INDEPENDENT EXPERT EVIDENCE ADVICE

**AMENDMENT C171^{port} TO THE PORT PHILLIP PLANNING SCHEME
ST KILDA MARINA – 42 A-E MARINE PARADE ELWOOD**

March 2020

THE PROPOSED DPO RESPONSE

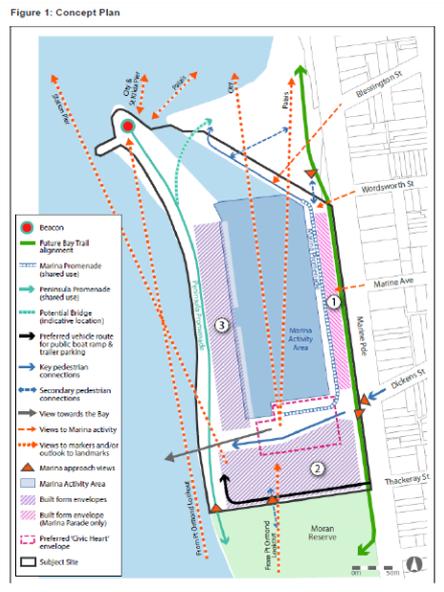
96. The proposed DPO response recognises many of the shortcomings of the current arrangements and the changed nature of both its abutments and the role of this facility within an expanding Melbourne.
97. The views towards the Foreshore are preserved from all of the adjoining streets save Thackeray Street to the south.
98. Views to the Beacon are preserved from the MO Moran Reserve shared coastal path interface although views from the Elwood Canal Bridge currently available would be lost. Views to the

Beacon from the adjoining Marine Reserve are preserved. A view line is also established from the Point Ormond Lookout to and through the site to the Palais to the north via a proposed zone for a new publically accessible Civic Heart terminating the southern end of the safe harbour.
